25 November 2019

**Wellington Solar Farm Modification Application (SSD 8573 Mod 1)
Amendment to Modification Application**

Figure 1: Updated substation expansion footprint

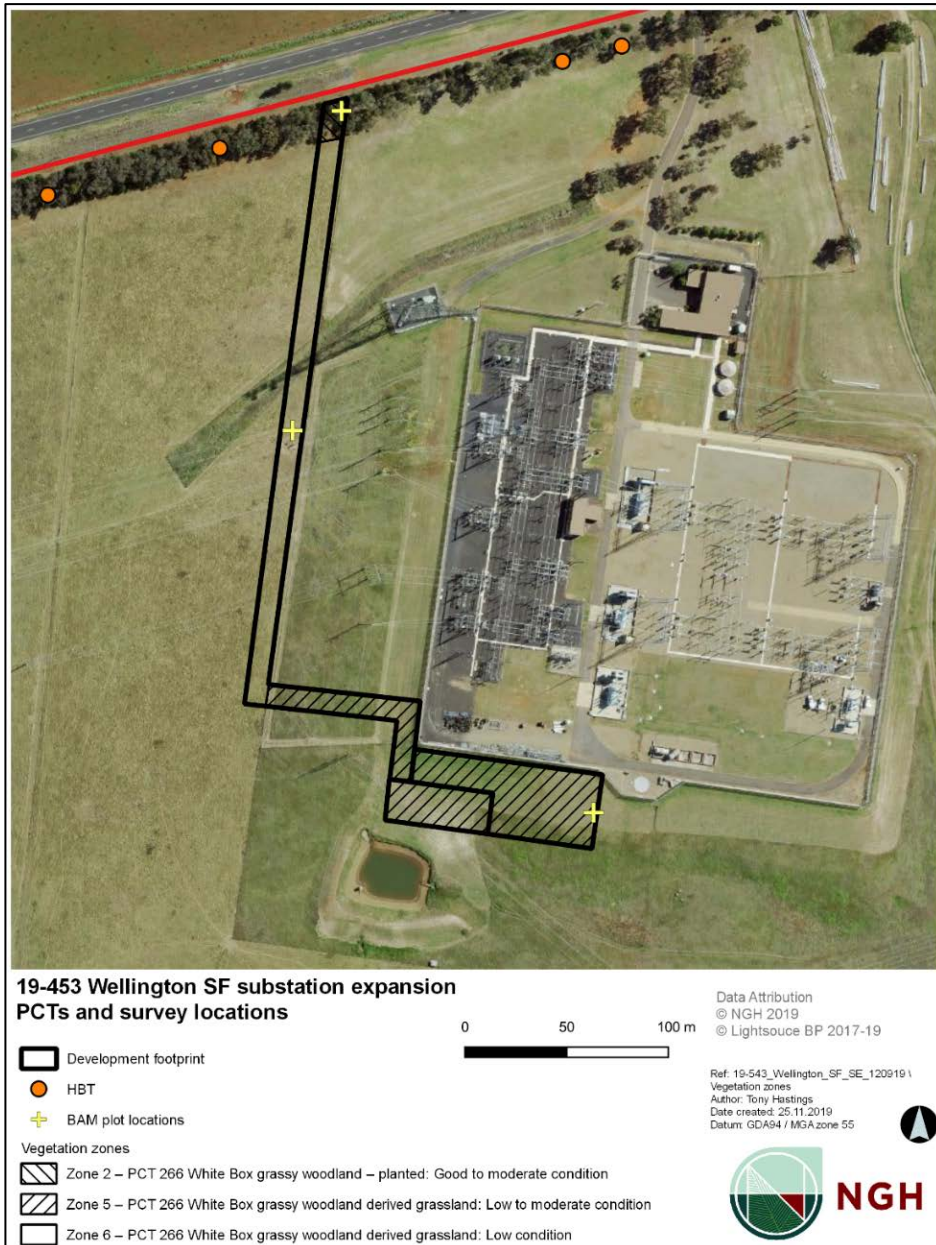
The additional area for the batter is comprised of 0.1 ha of Vegetation Zone 5 (PCT 266) – White Box grassy woodland derived grassland (moderate to low condition). The location of the additional area is within the project site previously surveyed by NGH, hence Plant Community Types (PCTs) and BAM plot data are available for this area.

With the inclusion of this additional area, the modification application would require 0.78 ha of ground disturbance, comprised of the following vegetation communities:

- Vegetation Zone 2 (PCT 266) - White Box grassy woodland – planted (moderate to good condition) - 0.02 hectares (ha)
- Vegetation Zone 5 (PCT 266) - White Box grassy woodland derived grassland (moderate to low condition) - 0.46 ha
- Vegetation Zone 6 (PCT 266) - White Box grassy woodland derived grassland (low condition) – 0.30 ha

Refer to Figure 1.

Re-running the Biodiversity Assessment Method (BAM) calculator on 21 November 2019, for this small change in area for Zone 5 did not require any additional plot data; the minimum plot requirements of the BAM have been met. Further, no habitat features would be impacted. Refer to Figure 1 for expanded fill area and location of existing plots and habitat features.
